Narrative Describing Proposed Chapel Hill Cooperative Preschool

**RE: Proposed Site Plan for
Chapel Hill Cooperative Preschool
108 Mt. Carmel Church Road
Chapel Hill, NC 27514**

Philip Post & Associates, a Division of Pennoni; on behalf of the Chapel Hill Cooperative Preschool hereby resubmits the following documentation for the Site Plan Approval review for Parcels 9787-29-6199, 9787-29-7266, 9787-29-9047 and 9787-39-0045:

The above-mentioned documents have been revised in accordance with comments received from the Town of Chapel Hill Planning Department dated October 3, 2016 and comments received regarding the calculation of disturbed area. Please note that additional sheets have been added to the plan set for clarity. We offer the following responses to each comment:

PRE-DEVELOPMENT DRAINAGE AREA PLAN
 SHEET 1 OF 2

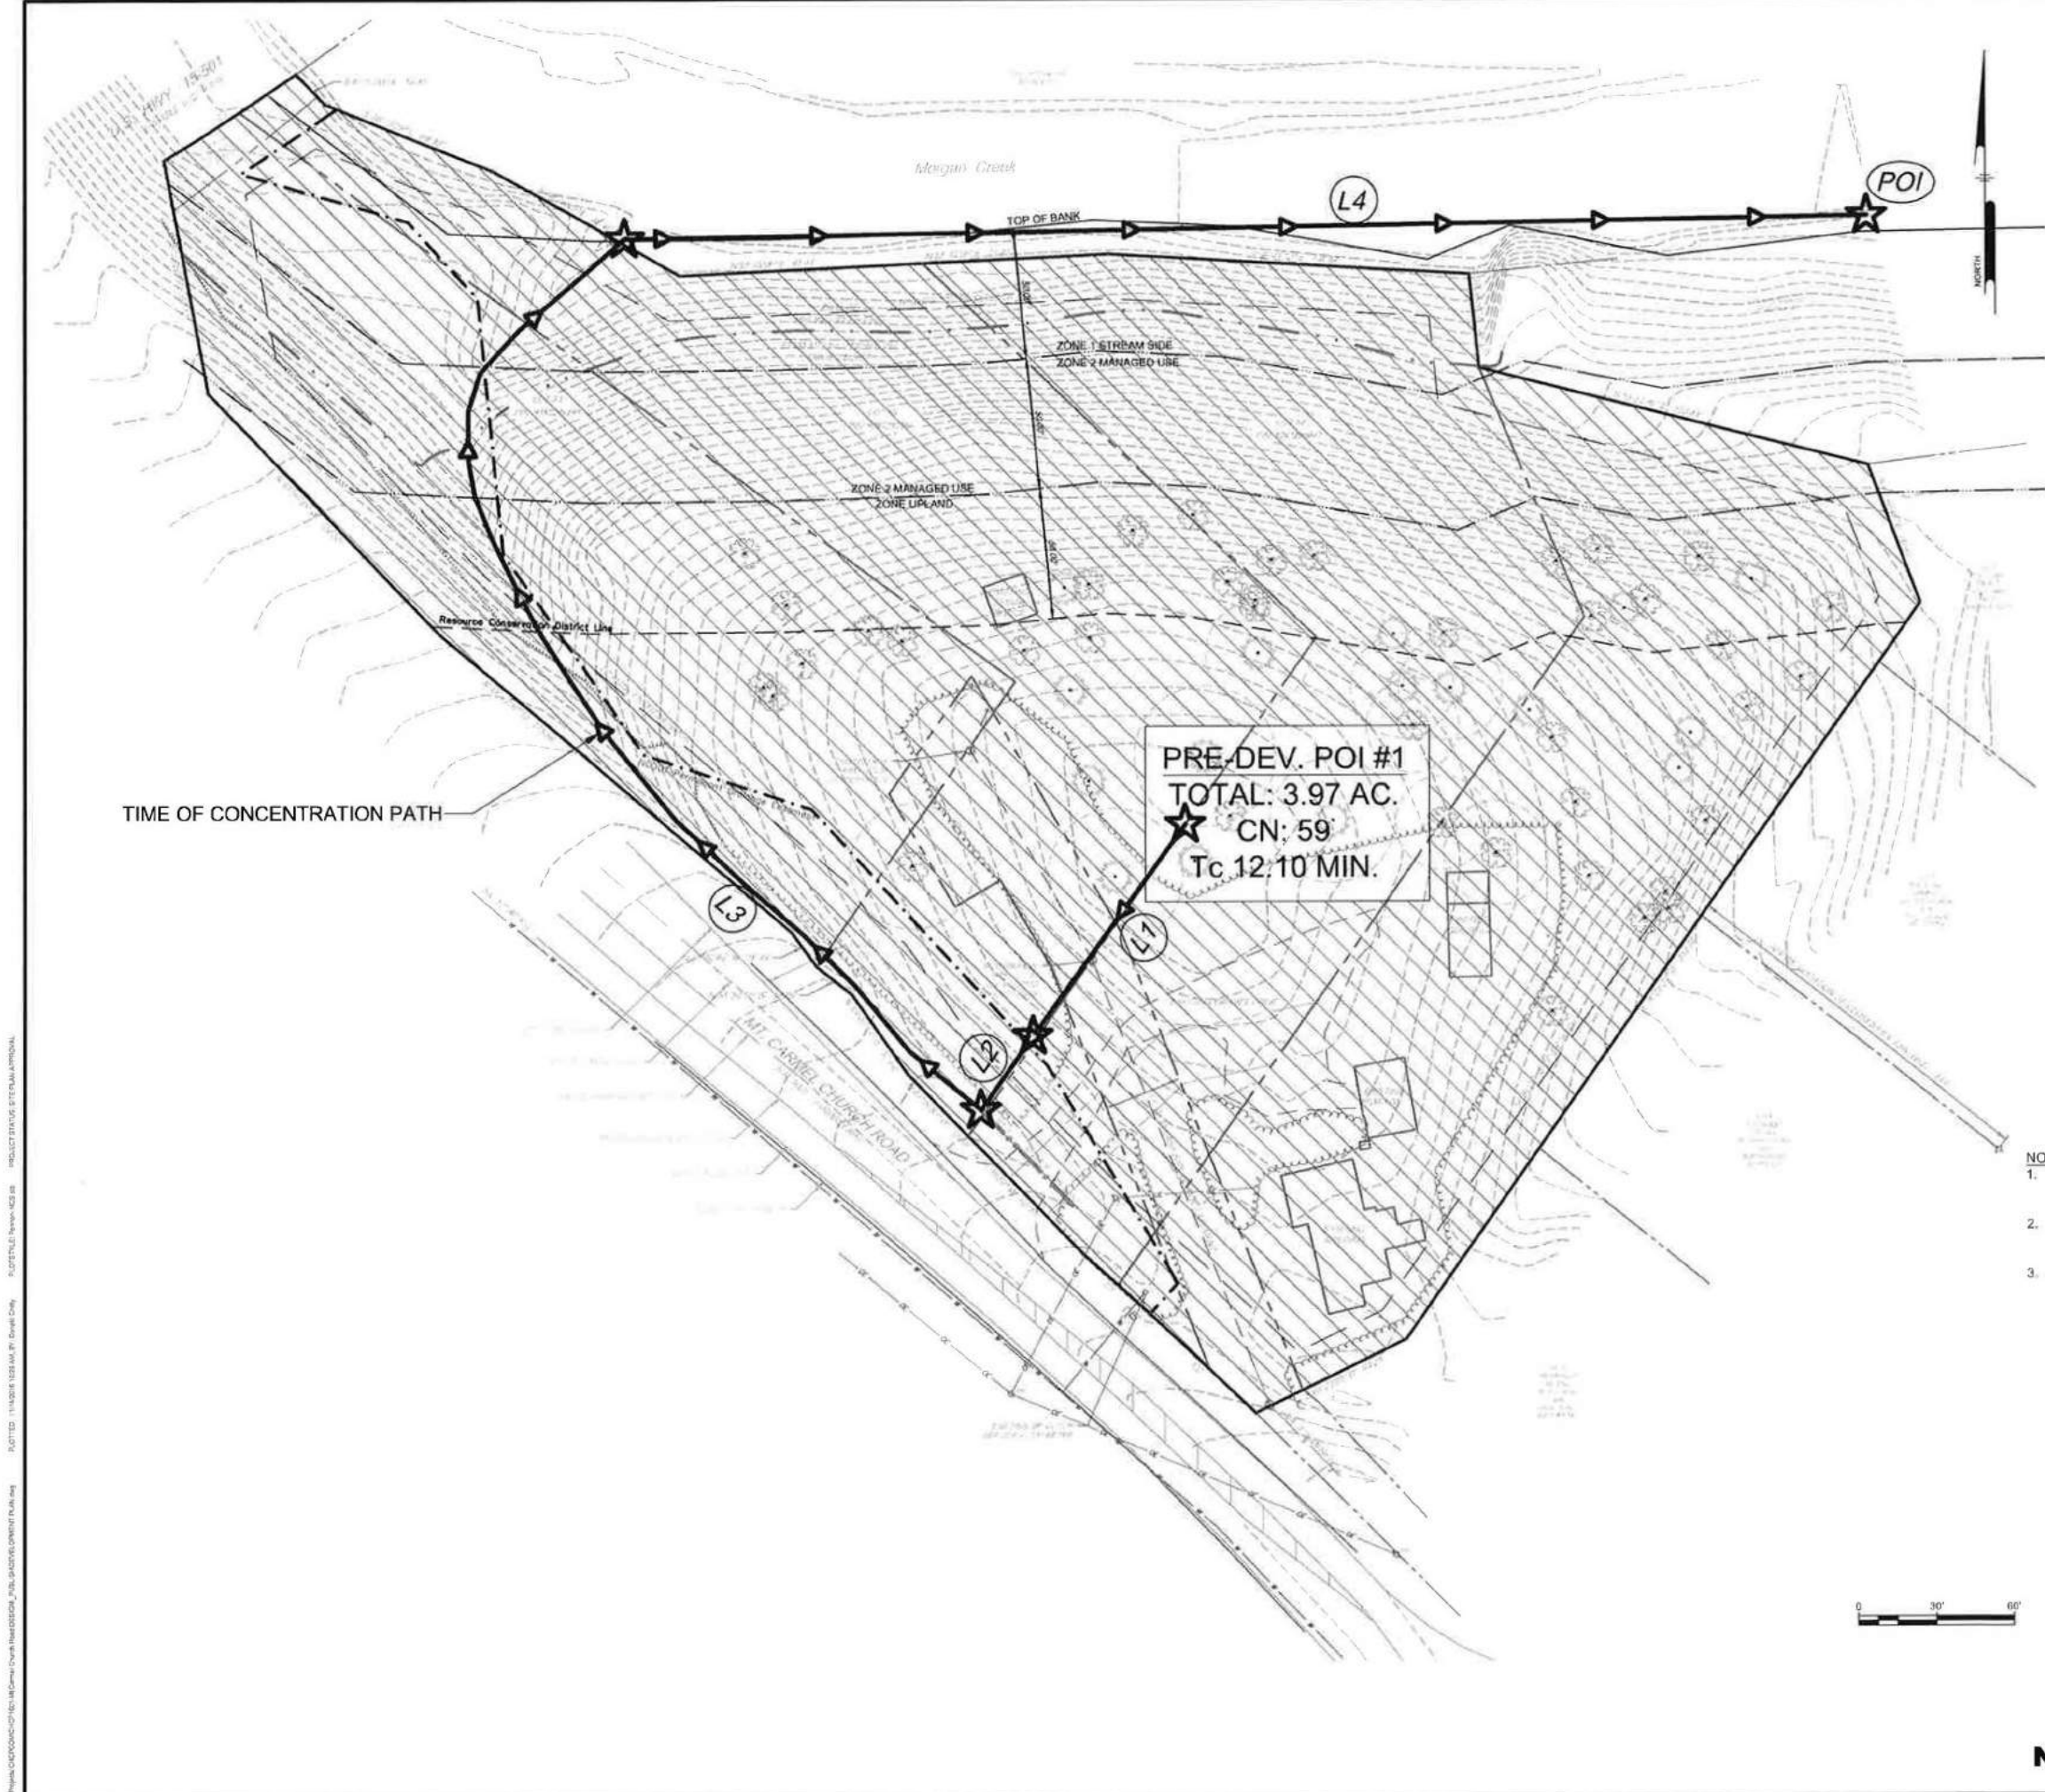
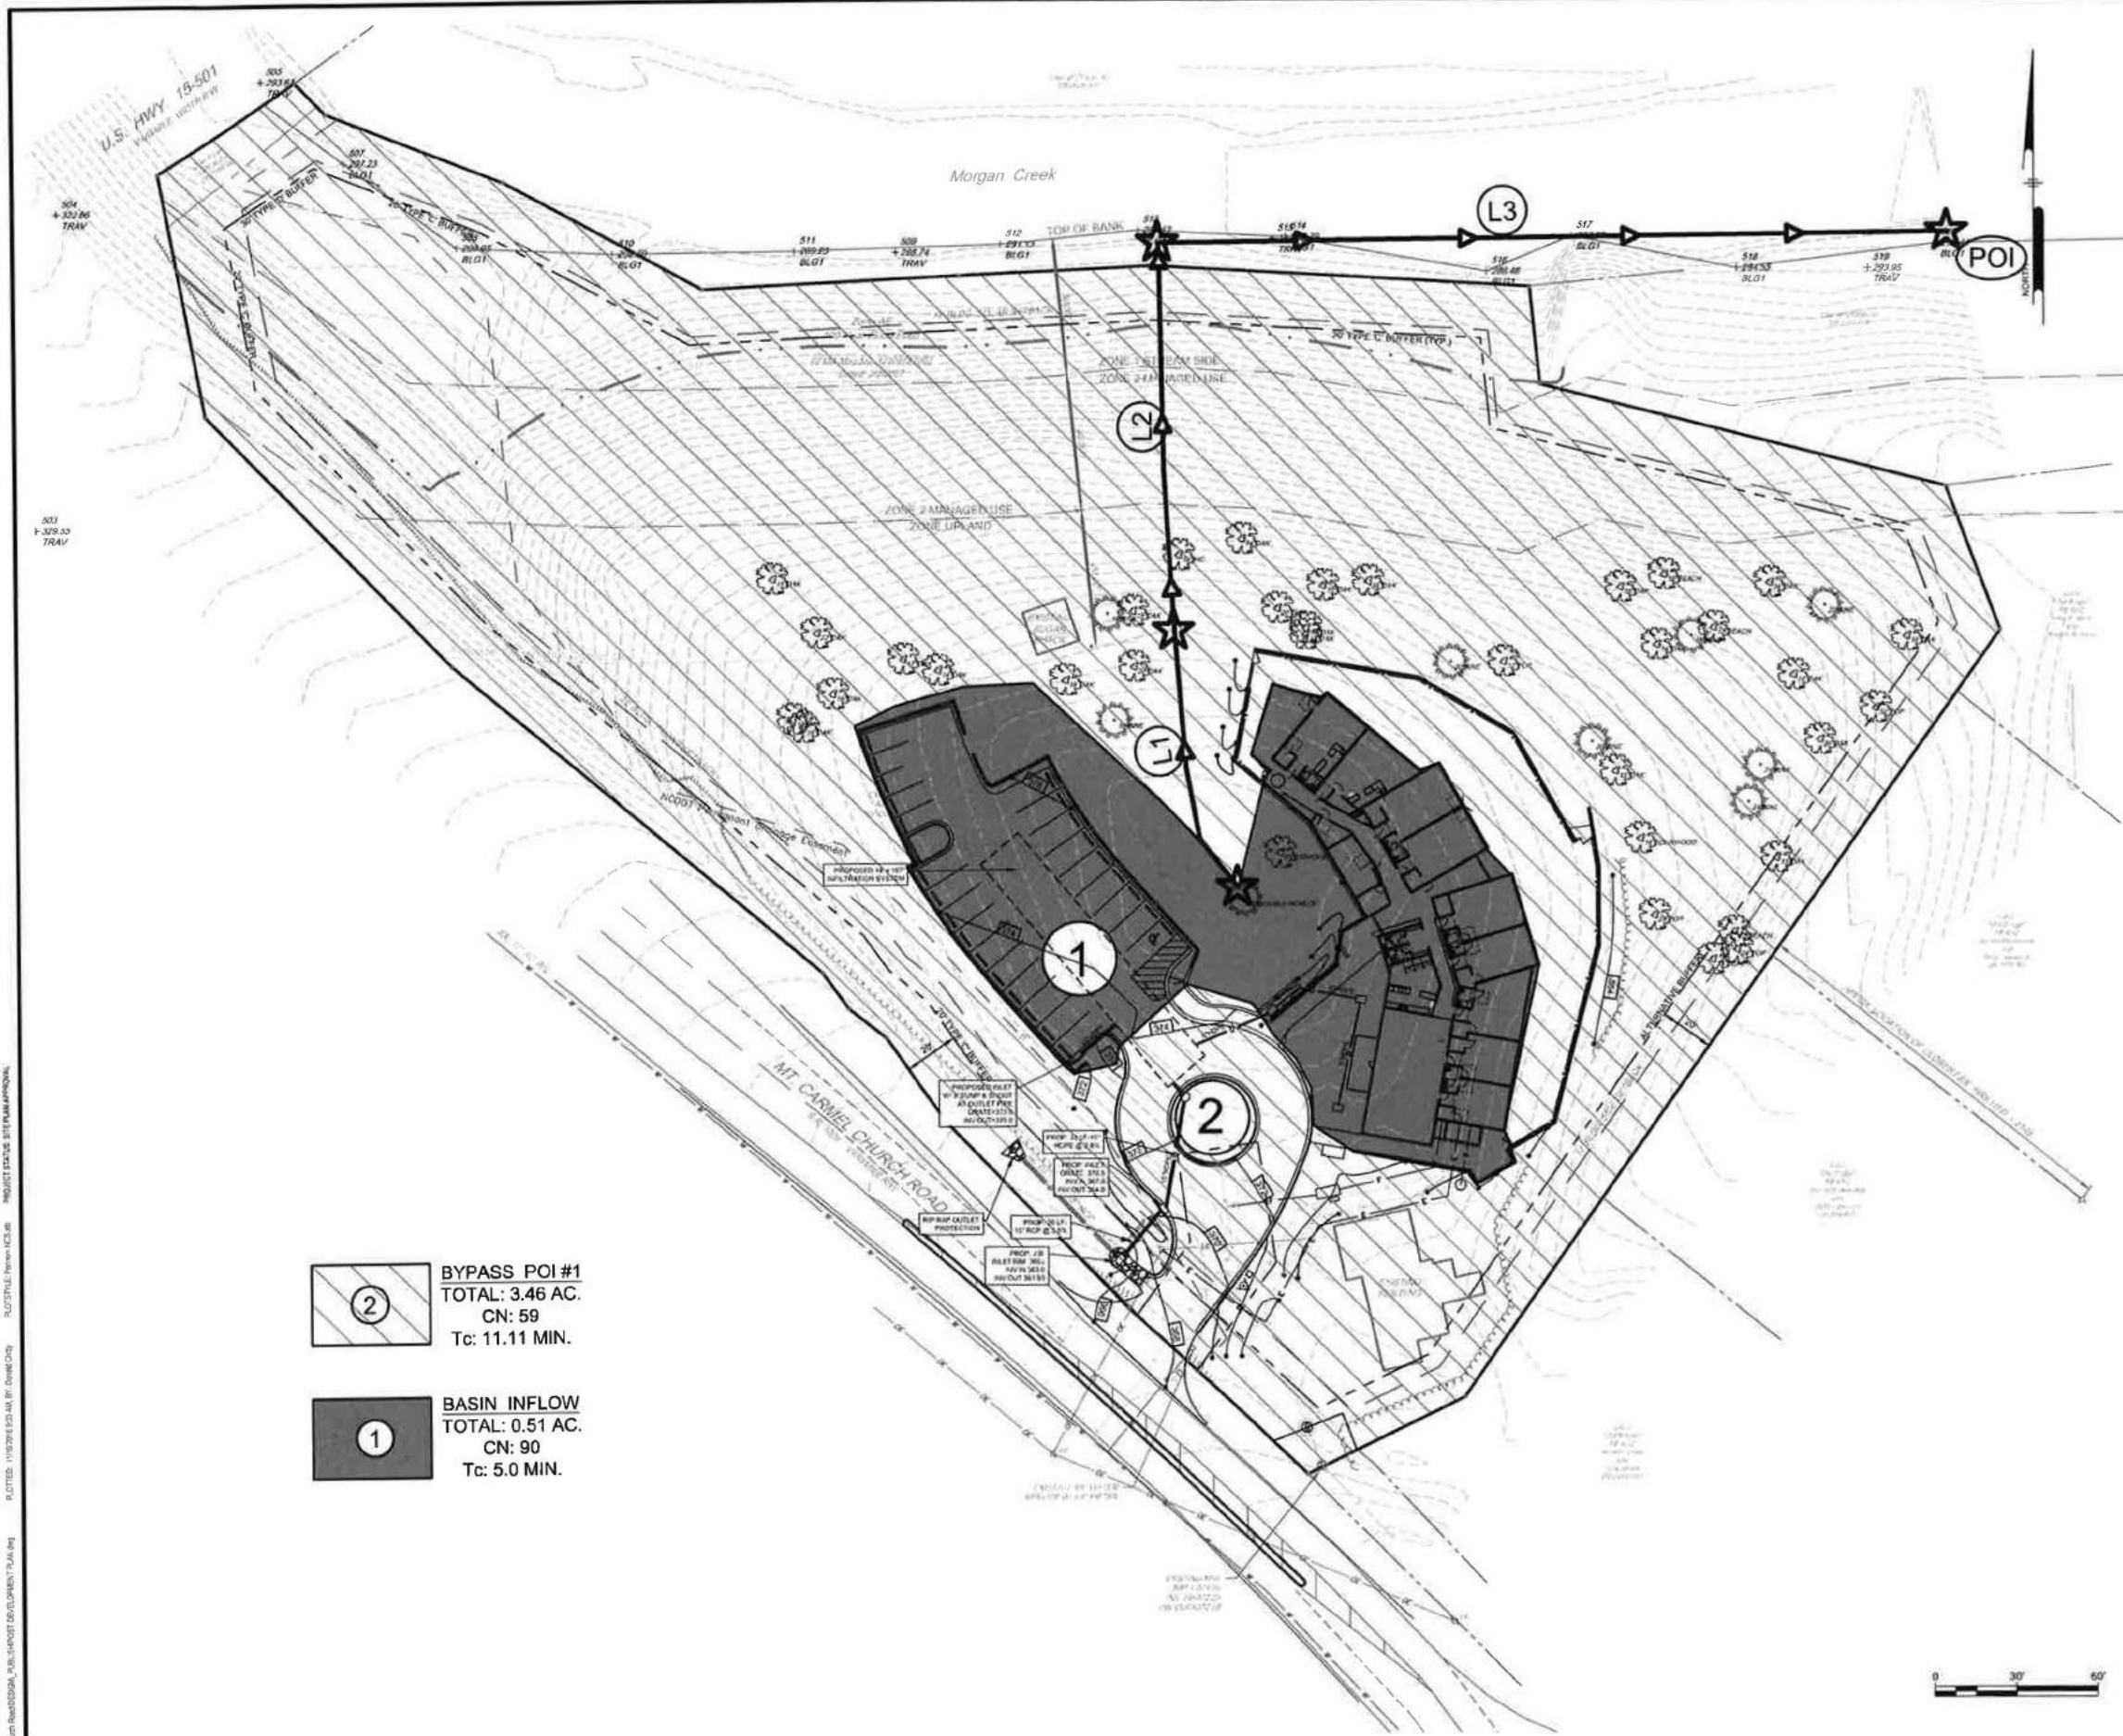
Comment 9- Provide pre and post-development drainage delineation map. The map should show the travel path used in computing the time of concentration to the point of analysis and areas bypassing stormwater treatment. (Stormwater)

Response: *This information has been provided in the amended stormwater report (attached).*
